Economic Commission for Europe**Inland Transport Committee****Working Party on the Transport of Dangerous Goods****Joint Meeting of Experts on the Regulations annexed to the European Agreement concerning the International Carriage of Dangerous Goods by Inland Waterways (ADN) (ADN Safety Committee)****Twenty-sixth session**

**Proposals for amendments to the Regulations annexed to ADN:
Other proposals****Explosion protection on tank vessels****Note by the secretariat¹**

Examples of mixed loading

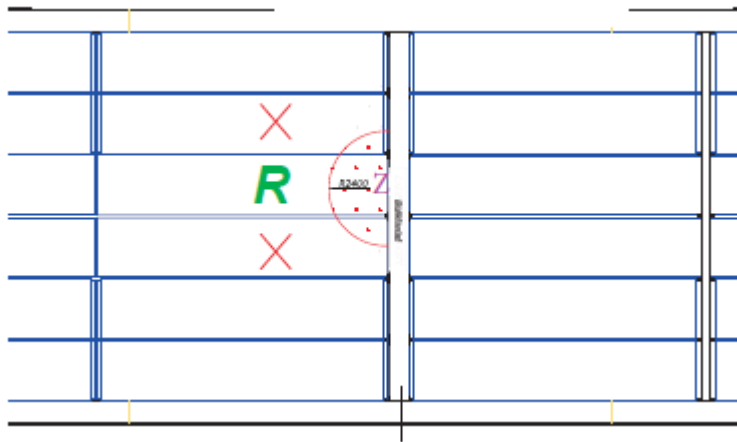
“7.1.4.4.4 Containers with electrical equipment are allowed to be connected with removable electric cables according to 9.1.0.56 or to be put into operation only if:

(b) The source of ignition of the container is separated sufficiently from containers containing substances of:

This condition is deemed to be met if no container containing the above-mentioned substances is stowed within an area of cylindrical form with a radius of 2.4 m around the source of ignition and an unlimited vertical extension.

This condition does not apply if containers which are not of a certified safe type and containers containing the above-mentioned substances are stowed in separate holds."
